AM OBJECTION & PETITION

APPLICATION No. **16/00194/MJR** APPLICATION DATE: 04/02/2016

LOCATION: BUTE STREET 152-160, BUTE STREET, BUTETOWN

PROPOSAL: DEMOLITION OF EXISTING WAREHOUSE BUILDING AND WORKSHOPS AND THE CONSTRUCTION OF 25 NO. RESIDENTIAL UNITS AND A SINGLE RETAIL UNIT (CLASS A1)

DRAWING TITLE:
SITE PLAN

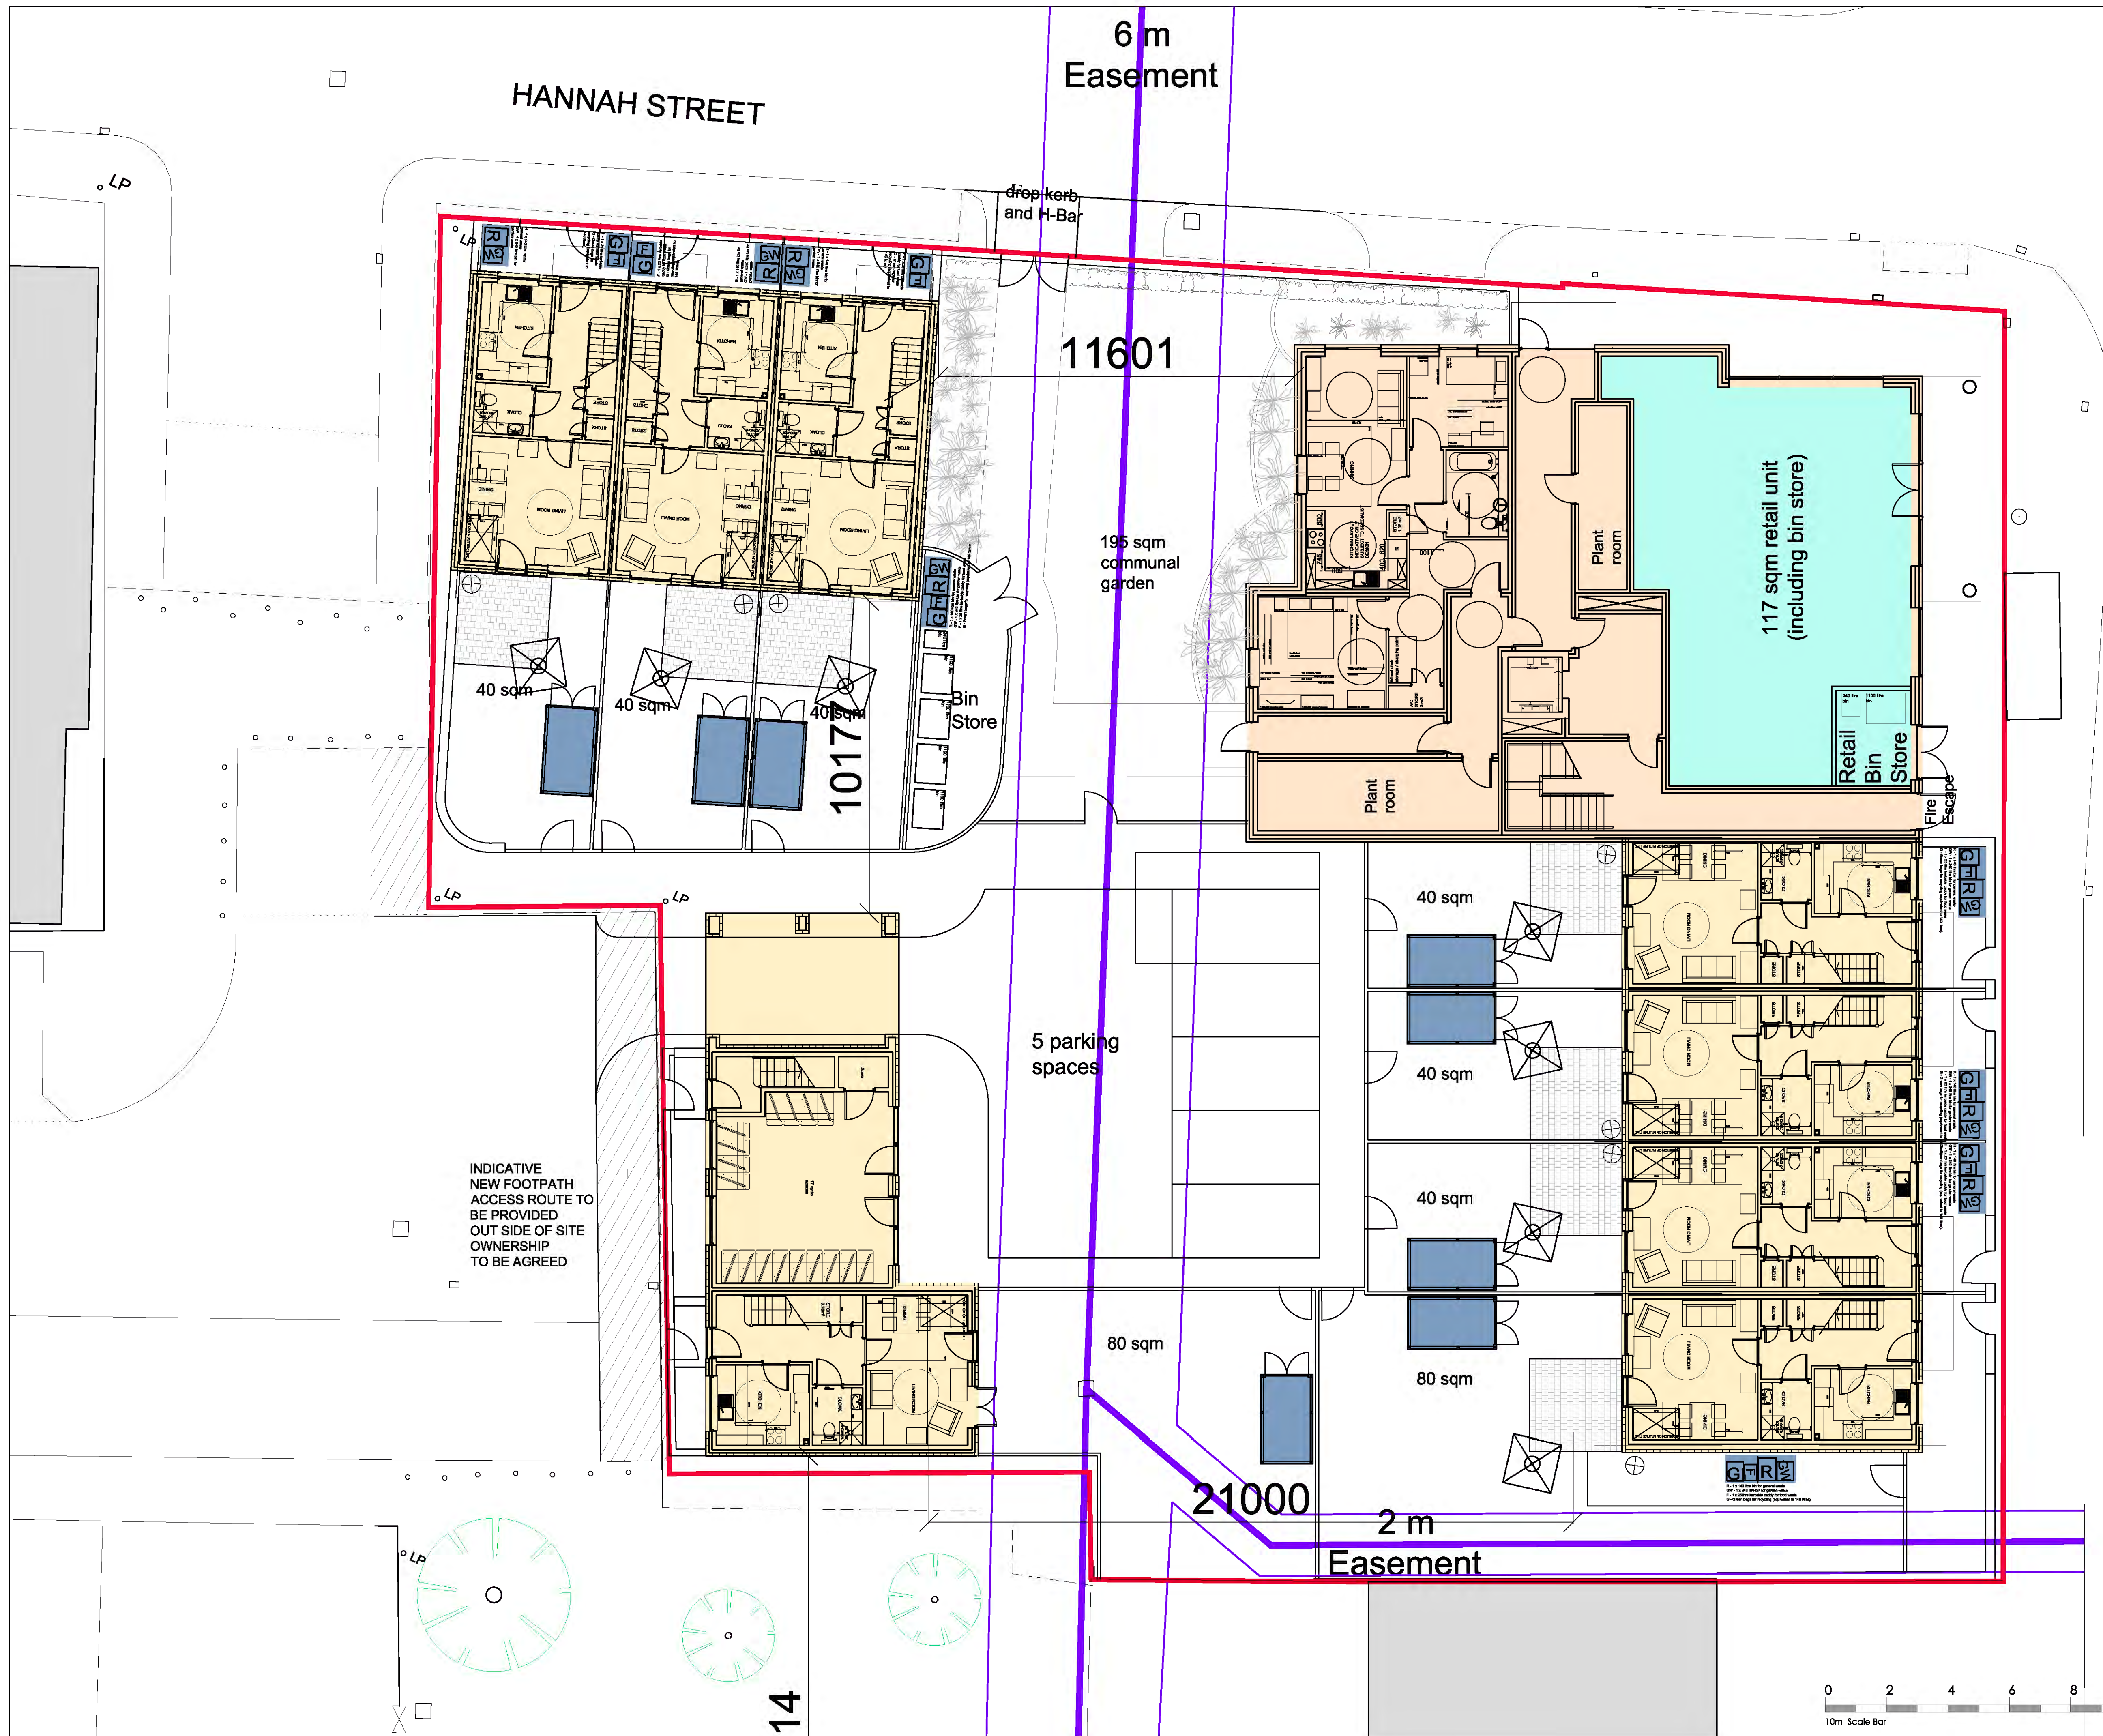
- The resurfacing of the footways bordering the site with 400x400 exposed aggregate silver-grey concrete slabs
- The removal of redundant vehicle cross-overs along Hannah Street
- The replacement of kerbstones along Hannah Street and to the rear of the site
- The provision of new footways to the rear of the site (as identified in the applicants 'proposed development site plan' PL(90)003).

- 5.5 The Waste Management Officer has submitted revised comments stating: Plans detailing refuse storage are acceptable. This area must be retained as refuse storage for future use. The concerns we have now is the access for the collection vehicles. My original comments on 9/2/2016, stated that vehicle tracking will be required to show that the collection vehicle can safely collect these bins. It is not clear whether the vehicle will be able to manoeuvre safely on the hammerhead turning area off Alice Street. The collection vehicle is not permitted to reverse down any roads, and must therefore be able to turn around on this access road.

Please submit amended site plans to show vehicle tracking for an Olympus-19N 6x2RS.

REV	DATE	DESCRIPTION	BY
F	15 04 16	Revised bin store layouts and positions	SH
E	04 04 16	Revised bin store access	SH
D	31 03 16	New bin store to retail and revised notation to bins. Revised fire exit and increase plant zones.	SH
